**BID ADDENDUM NO. 5**

Date of Addendum: April 24, 2026  
Issued for Bid Date: March 27, 2026  
Client Name: Public Schools of the Tarrytowns  
Project Name: 2024 Capital Bond Project – Phase 2; Washington Irving Intermediate School  
SED Project No.: 66-04-01-03-0-002-017  
TUFSD Bid Number: 25/26-TUFSD-003  
MEMASI Project No.: 101-2403  
Contracts: Contract 1: General Construction (GC)  
Contract 2: Mechanical Construction (MC)  
Contract 3: Electrical Construction (EC)  
Contract 4: Plumbing Construction (PC)

**1 SECOND FLOOR FRAMING PLAN - AREA A**  
SCALE: 1/8" = 1'-0"

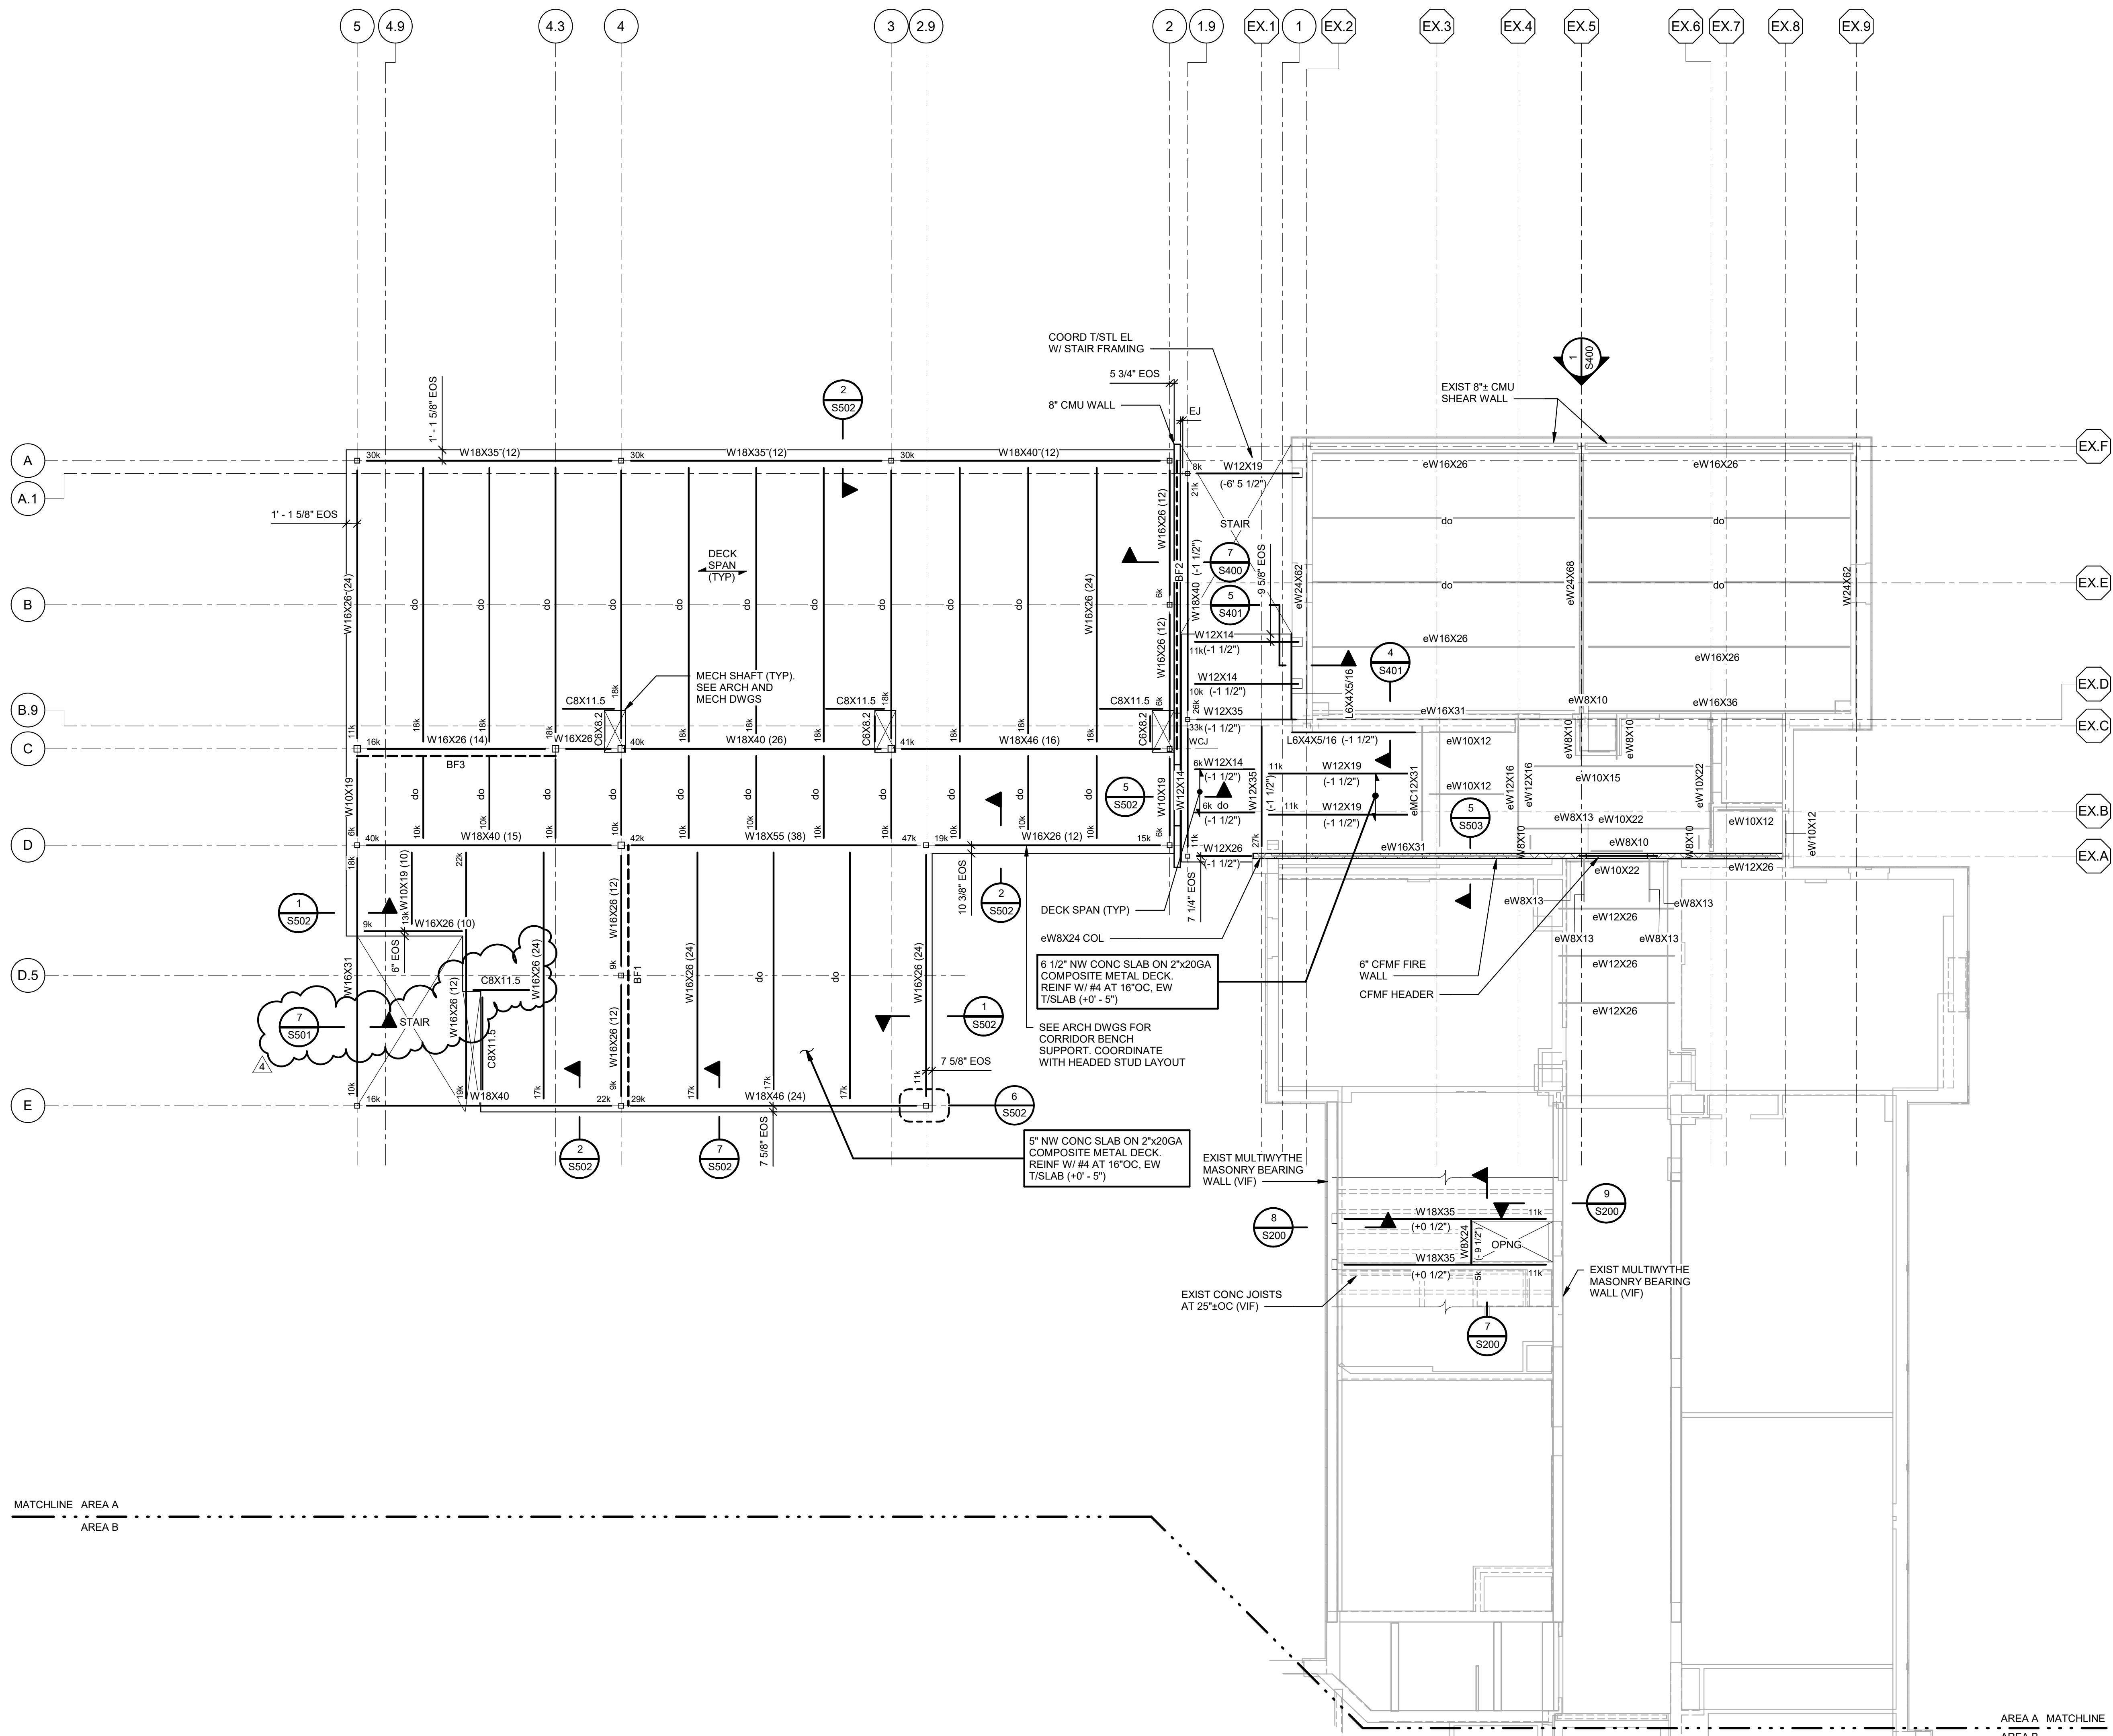
- r. SHEET S103 – SECOND FLOOR FRAMING PLAN – AREA A – REPLACE existing sheet S103, with new Sheet S103, attached, in its entirety. Revised 4/17/2026, attached.

9 SECTION  
S200

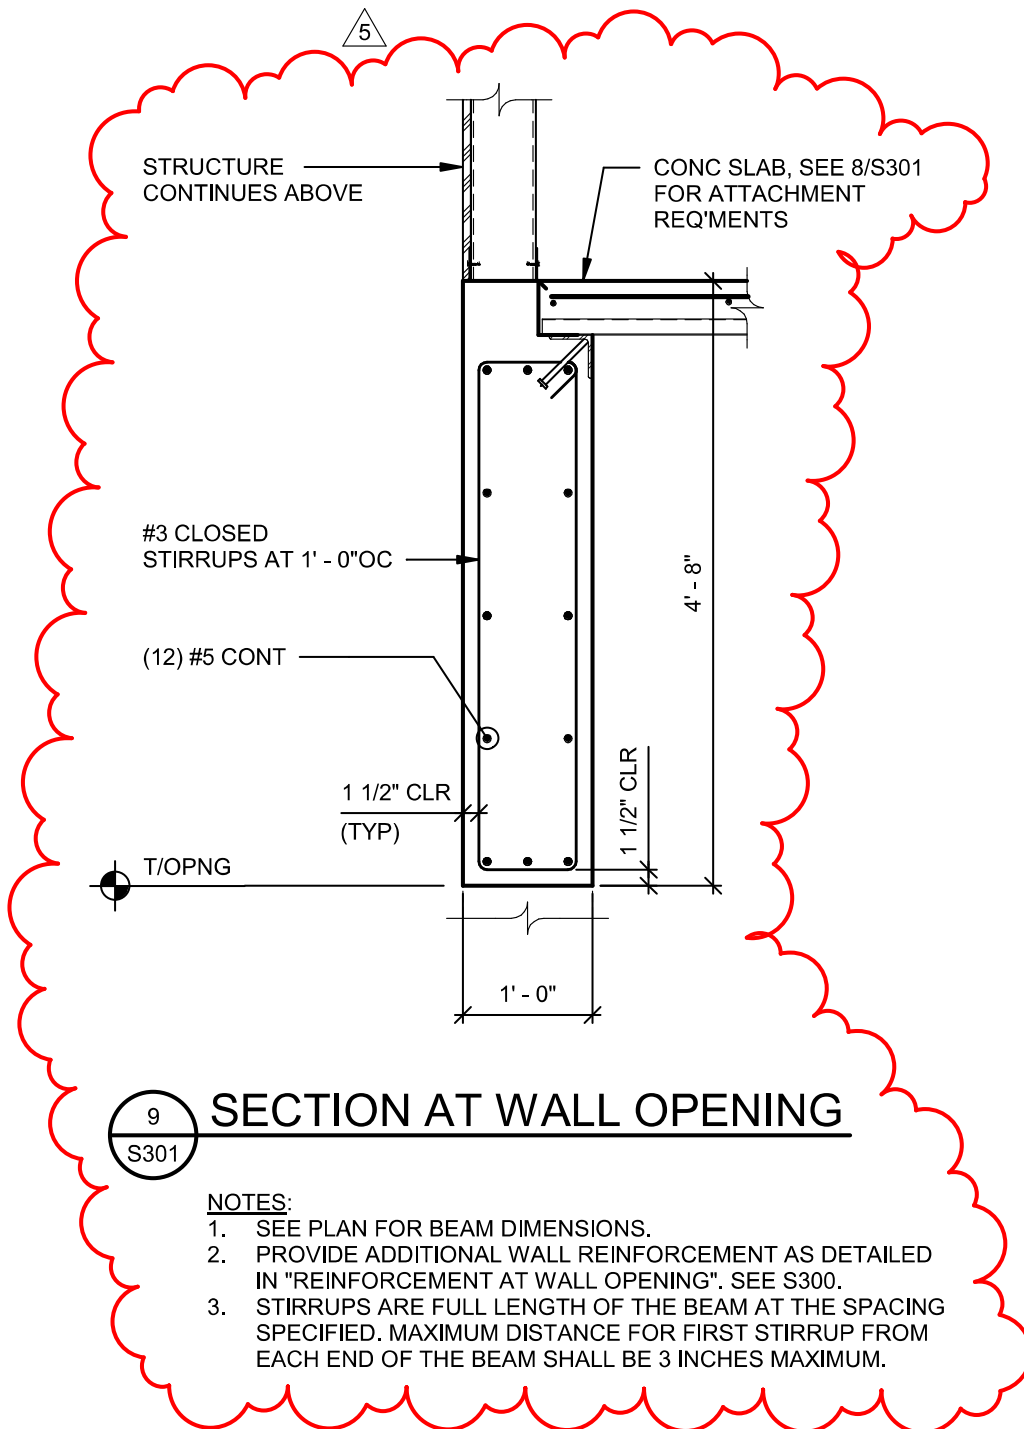
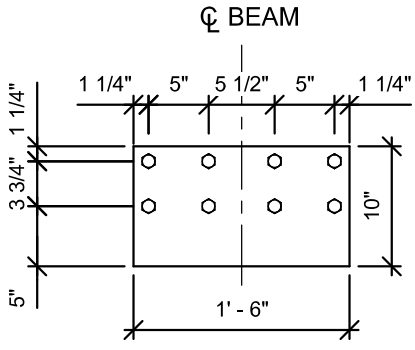
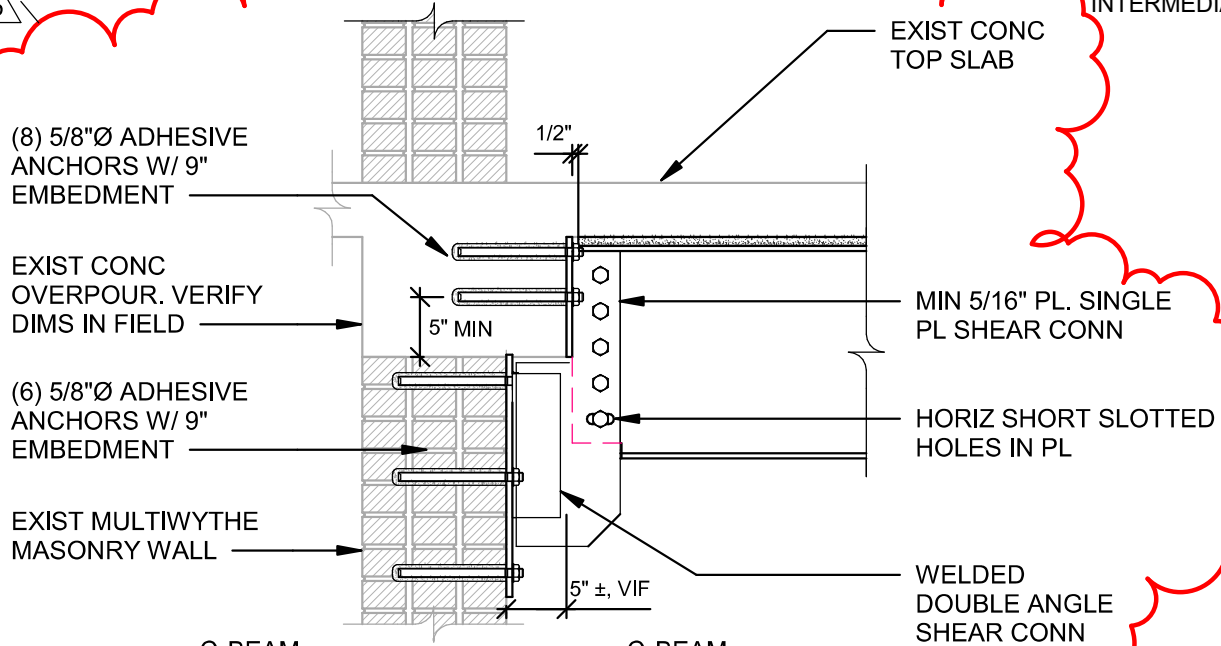
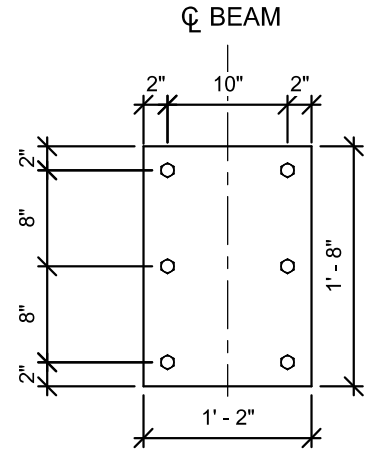
- s. SHEET S200 – PARTIAL PLANS AND DETAILS – DELETE existing Detail 9/S200. ADD Detail 9/S200 from the attached sketch, dated 04/23/2026.
- t. SHEET S301 – CONCRETE SECTIONS AND DETAILS – DELETE existing detail 9/S301. ADD Detail 9/S301 from the attached sketch, dated 04/23/2026.
